County of Los Alamos

Agenda - Final Planning and Zoning Commission

PLANNING & ZONING COMMISSION STAFF REPORT

Public Hearing Date: August 12, 2026
Subject: Case No. SIT-2026-0083
Applicant/Owner: Christus Health
Case Manager: Danyelle Valdez, Planning Manager

CUSTOM TURNING TEMPLATE FOR ESD, BASED UPON AASHTO SU-30, MODIFIED FOR 35' LENGTH

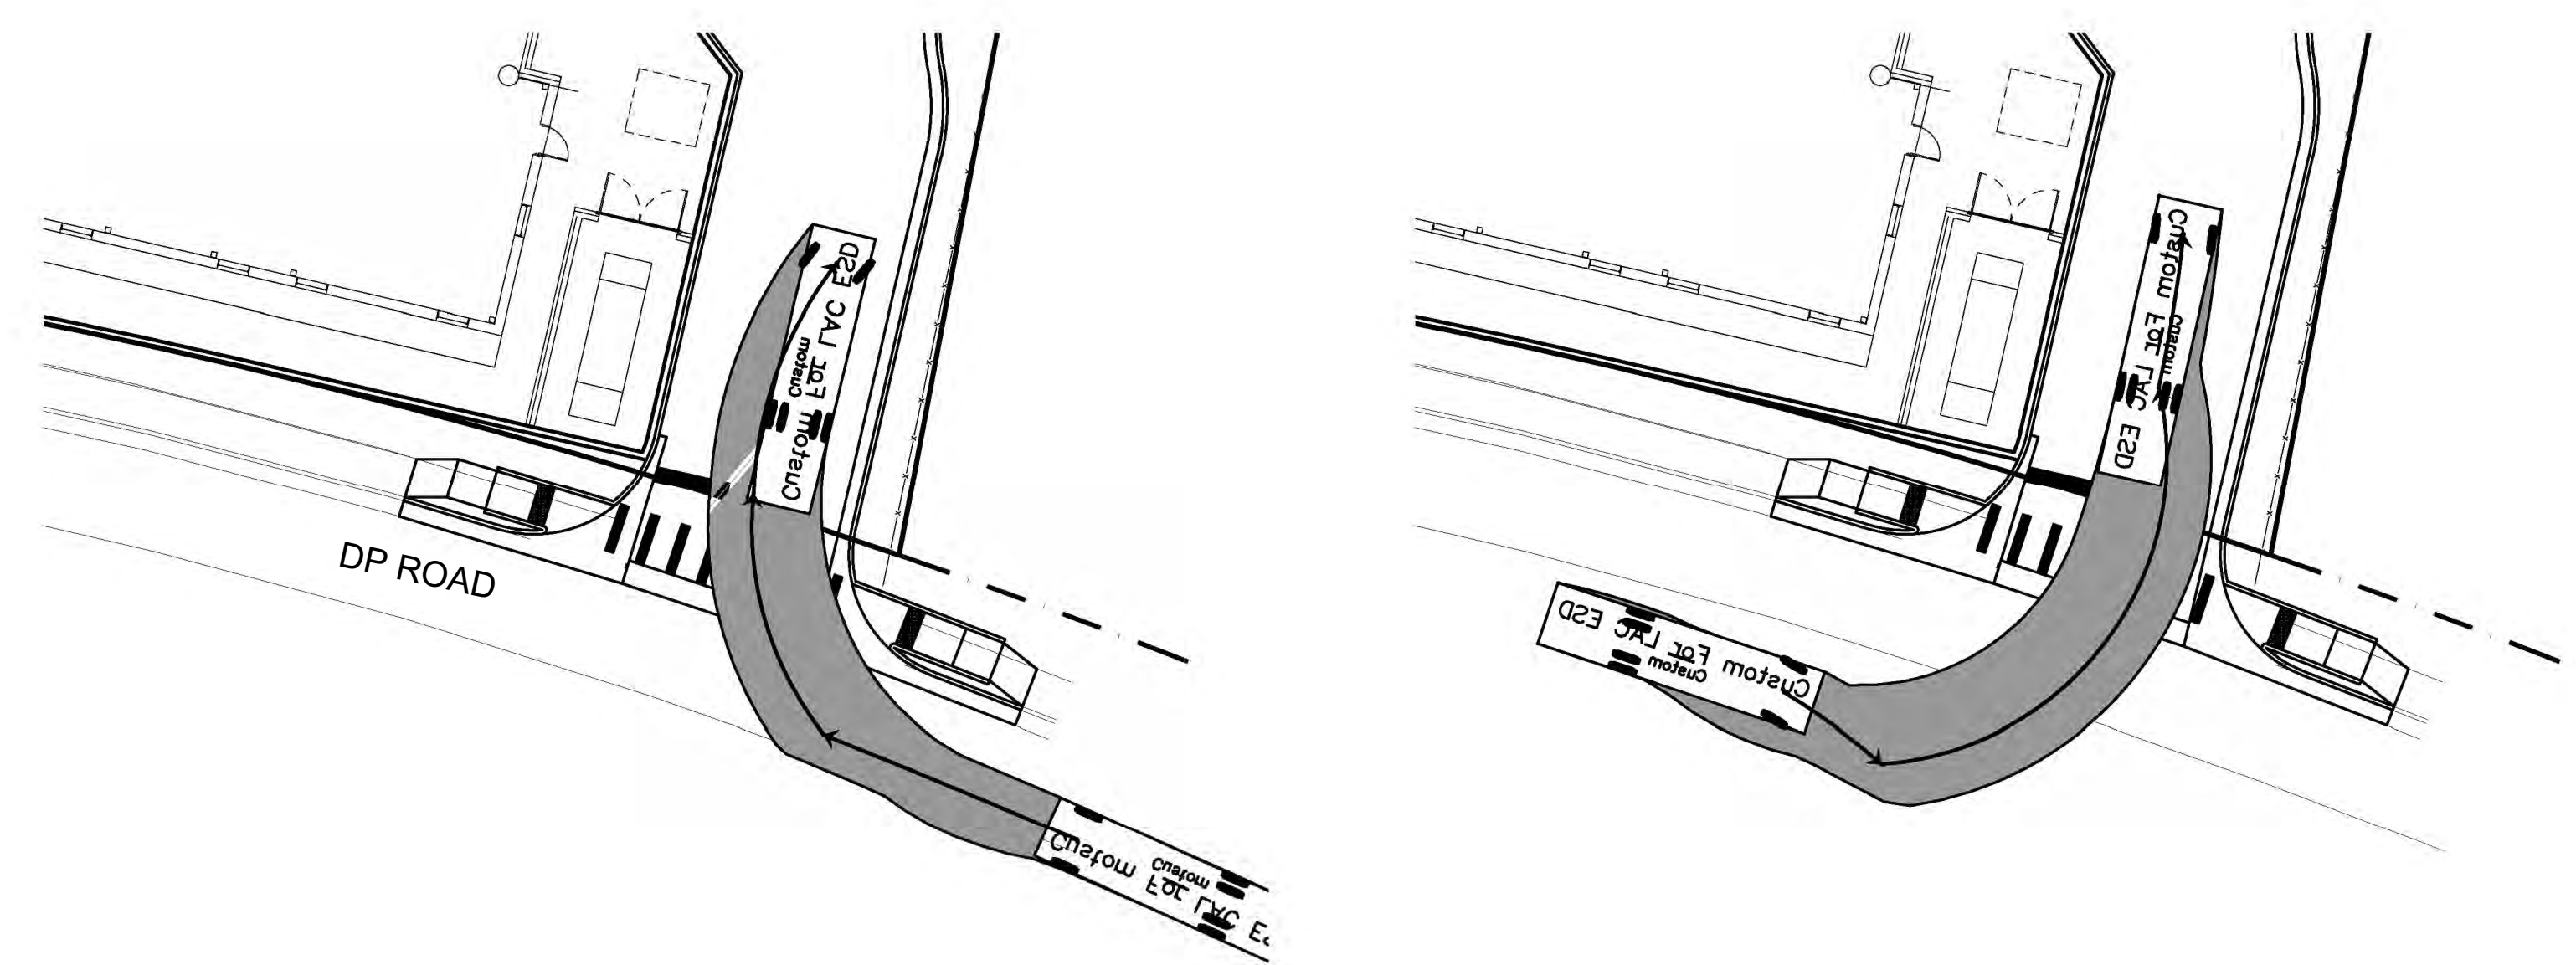
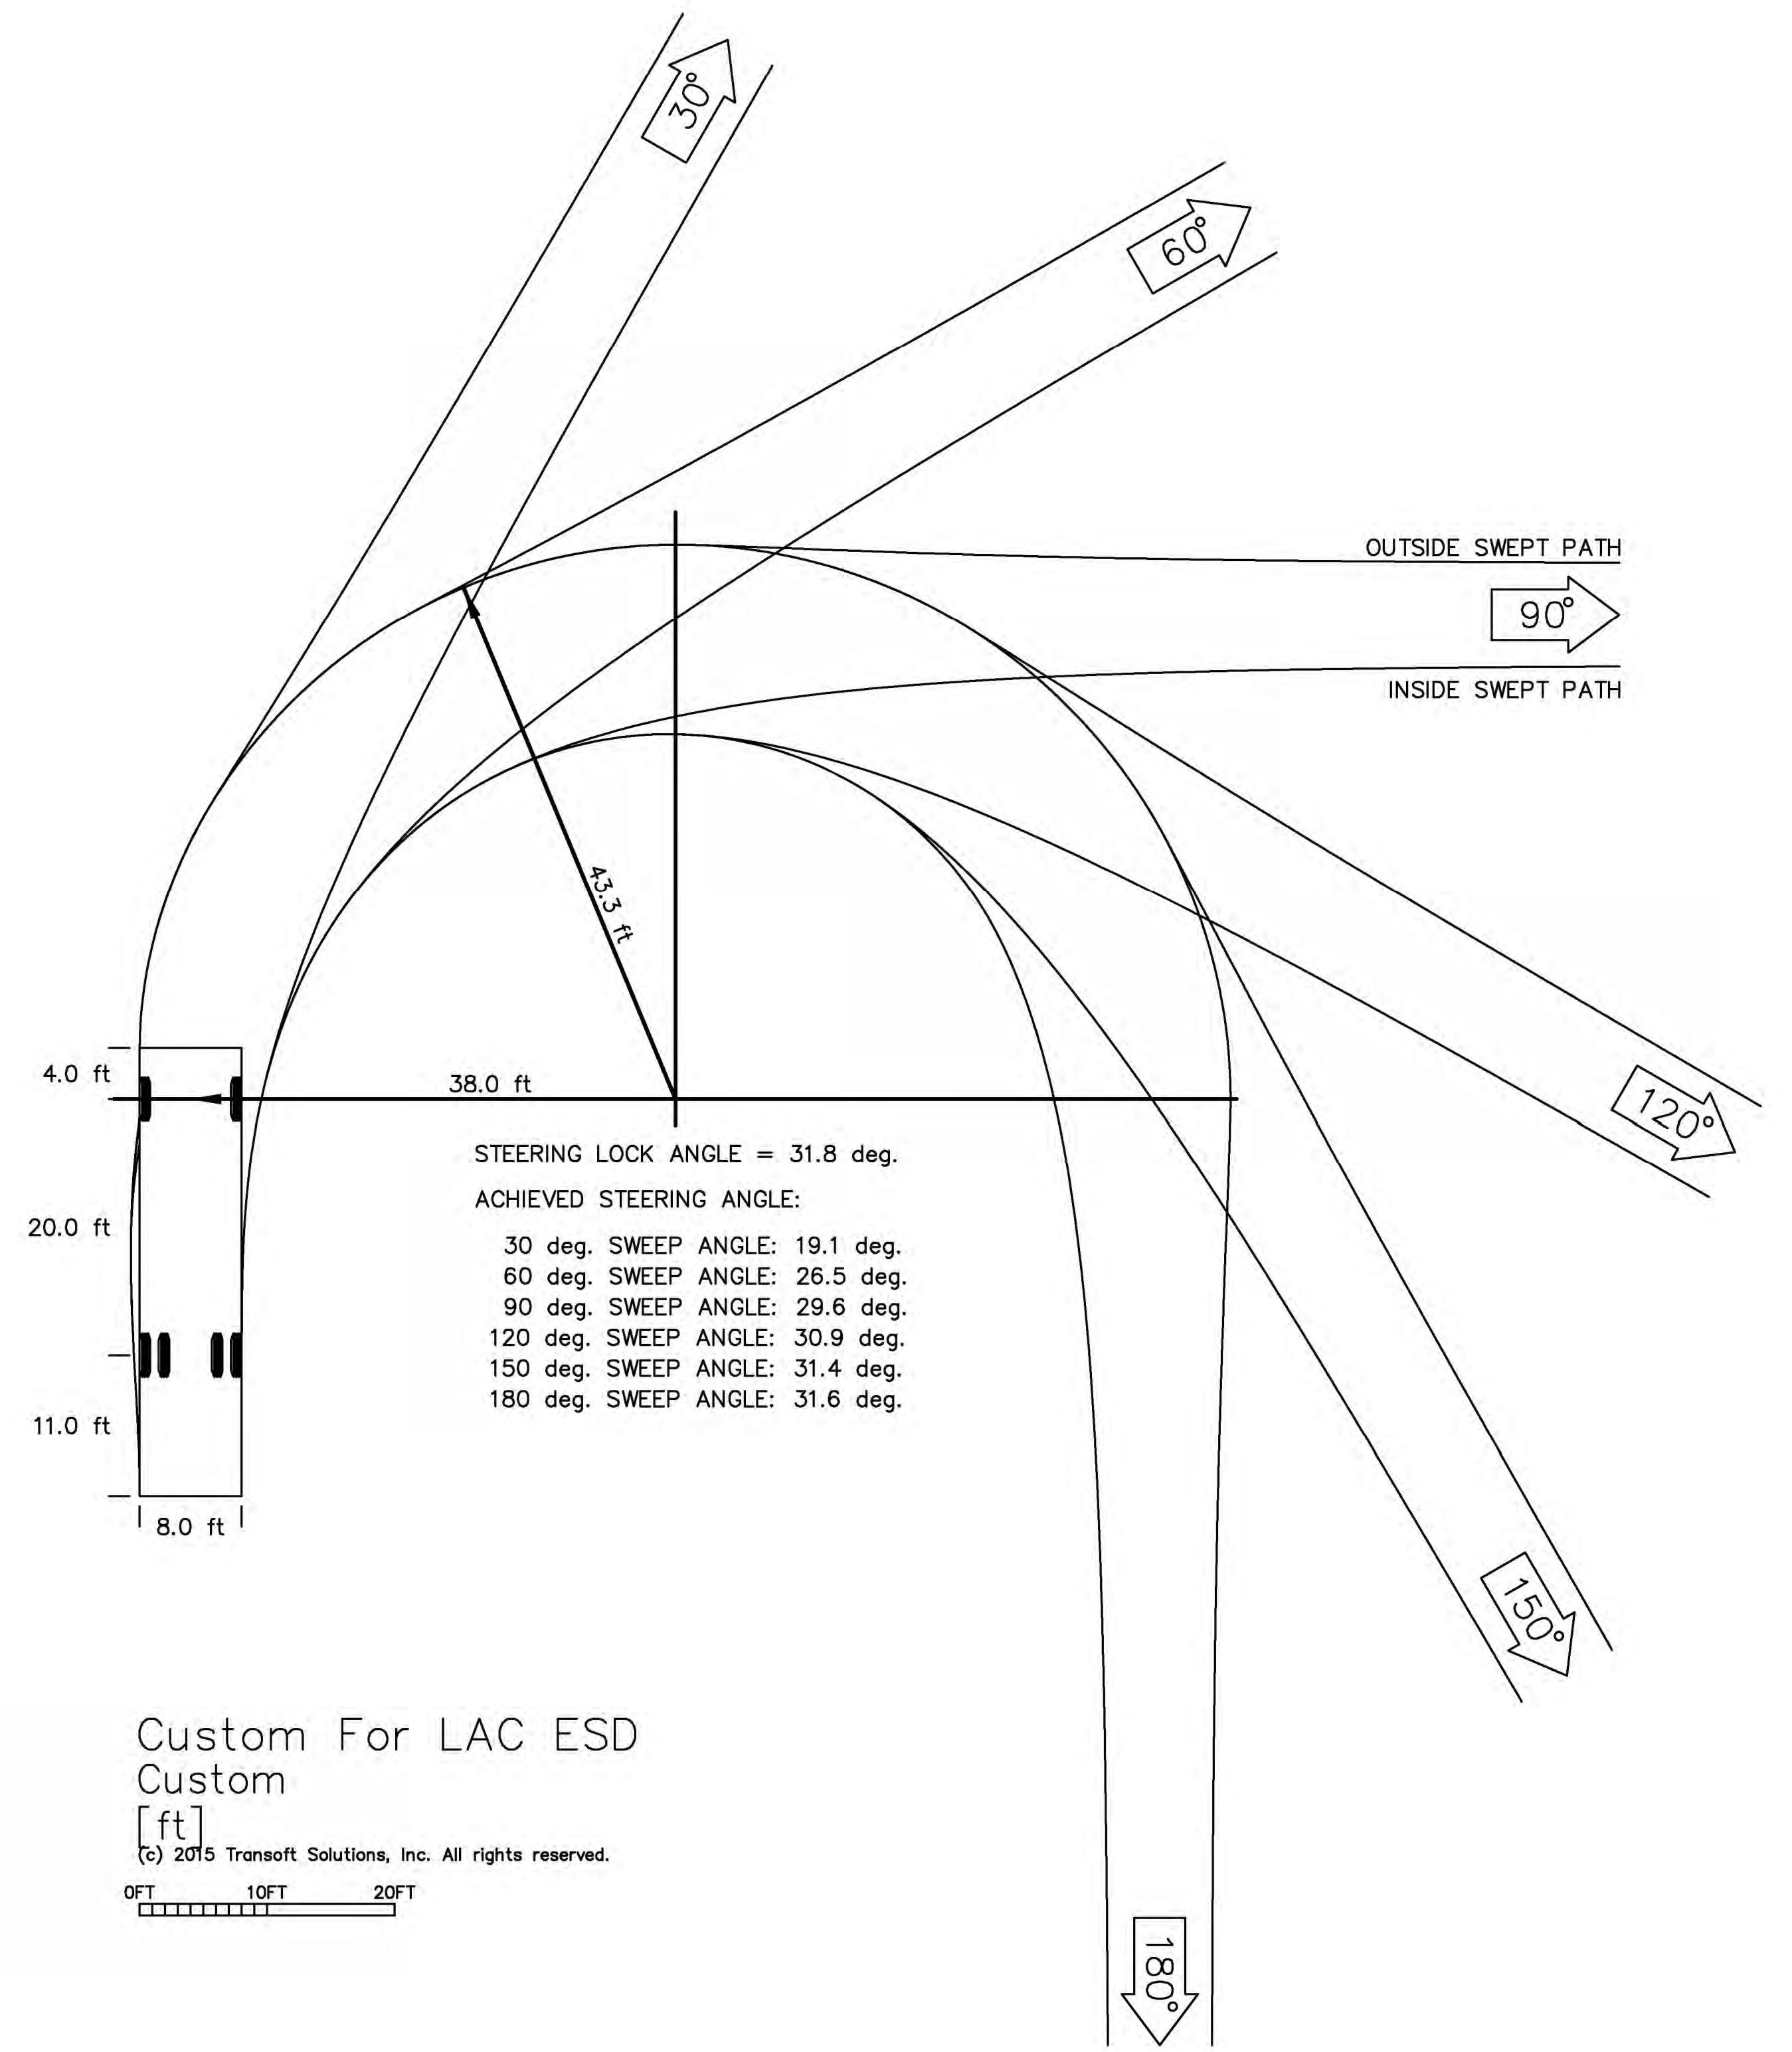
Environmental Services requested revised plans identifying the location of all refuse and recycling receptacles and demonstrated adequate access and egress for collection vehicles. Environmental Services initially requested locating the collection area within the alley behind AutoZone, with vehicles entering from Trinity Drive and exiting onto DP Road to establish a one-way circulation pattern aligned with the facility loading dock.

The applicant submitted revised drawings on July 31, 2026, showing the dumpster enclosure, collection location, and vehicle turning movements. Environmental Services reviewed and accepted the revised drawings that include locating the collection area along the eastern portion of the subject property to align with the proposed driveway access from DP Rd.
